Saint Ignatius' College - s4.55 Modification to SSD 7140

JULY 2020

Saint Ignatius' College
RIVERVIEW

Proposed Modifications

REVISED FUTURE STAGES | UPGRADE RECREATION COURTS PRECINCT

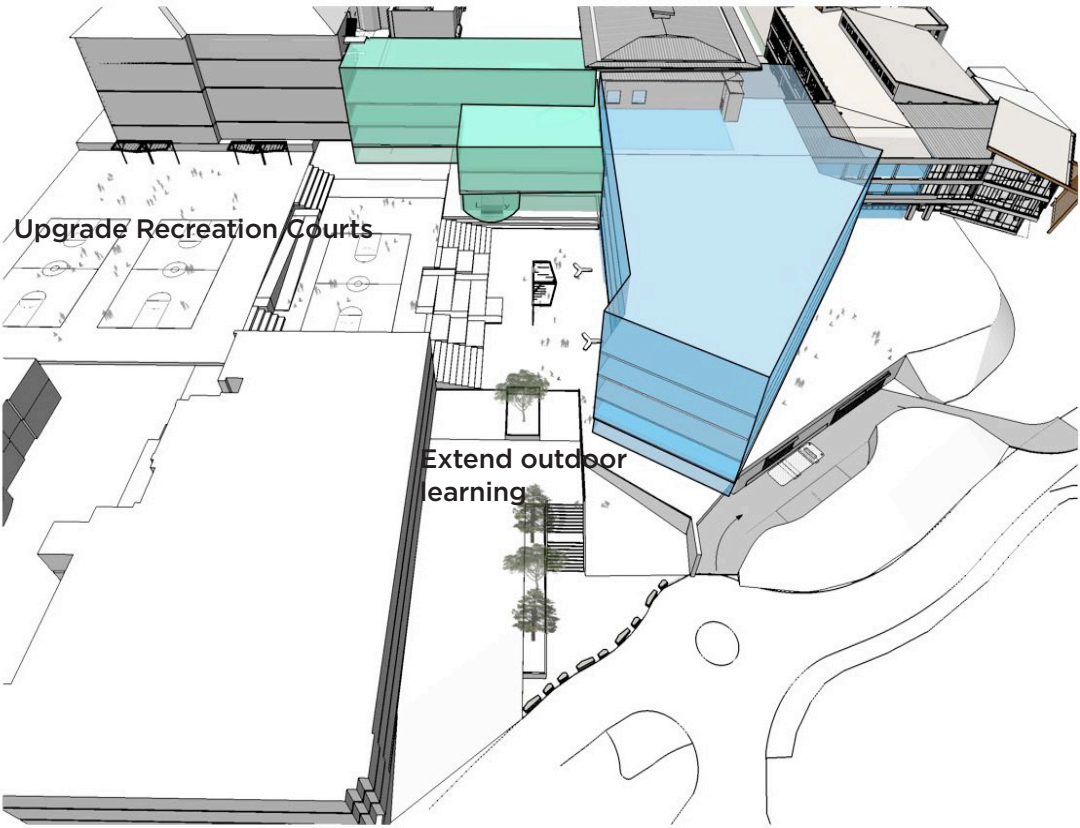
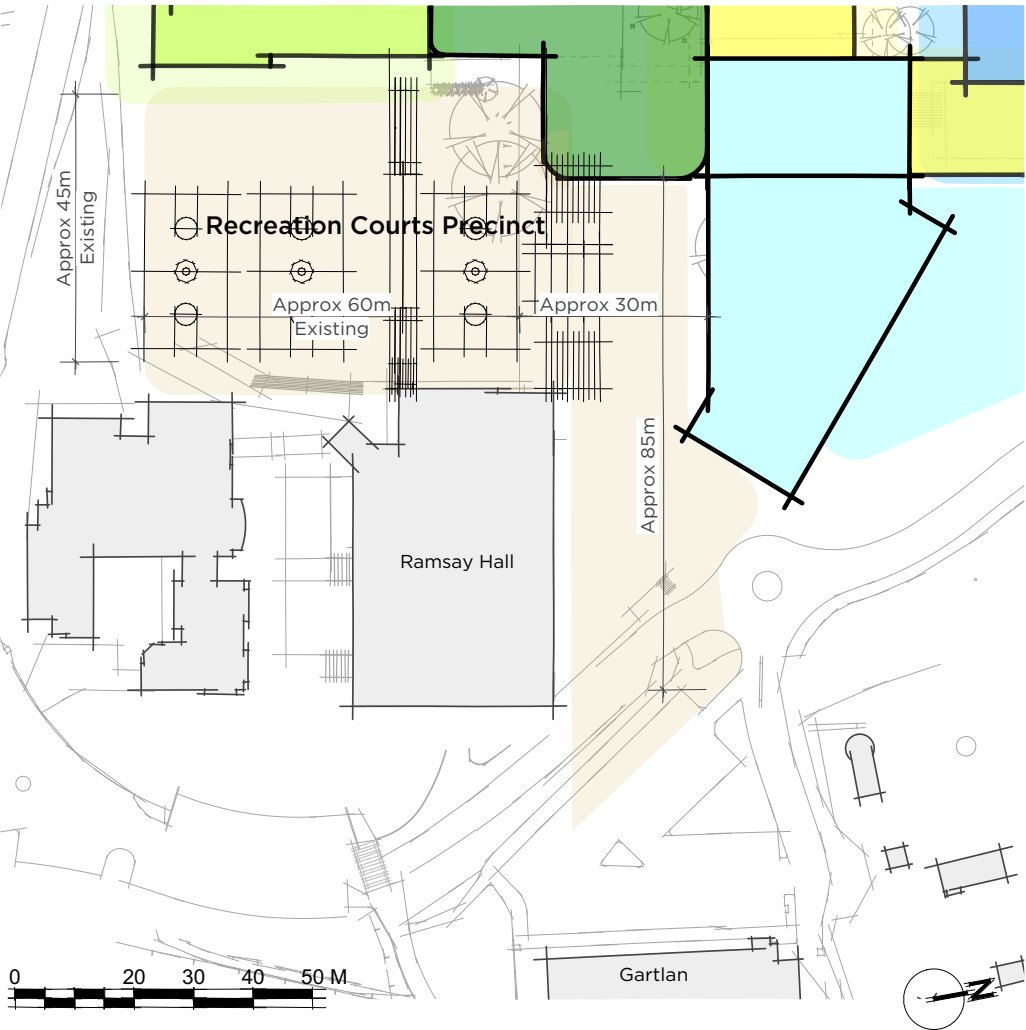
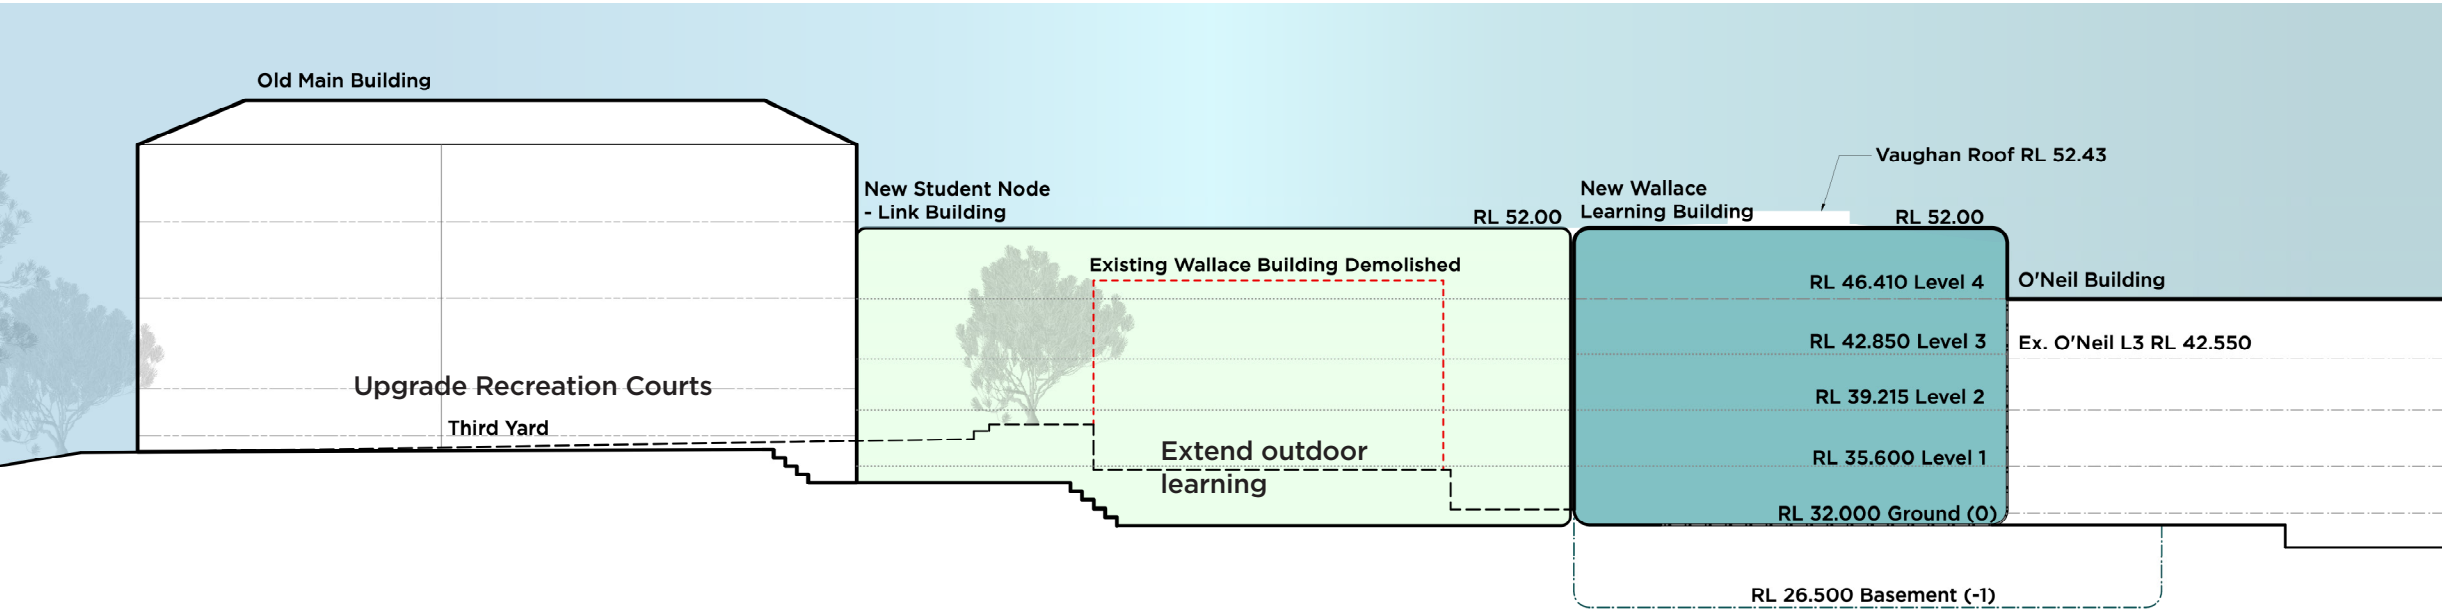
- Additional GFA = Nil
- Number of Levels = 1

Remove approved podium design and replace with reduced proposal that focus on reinvention of existing outdoor and area left from the removal of Wallace to create purposeful and quality outdoor & recreational space. Solution is for creation of outdoor areas as extension of learning space, gathering opportunities and retaining the need for recreation areas for basketball and handball. No existing parking will be lost in this solution.
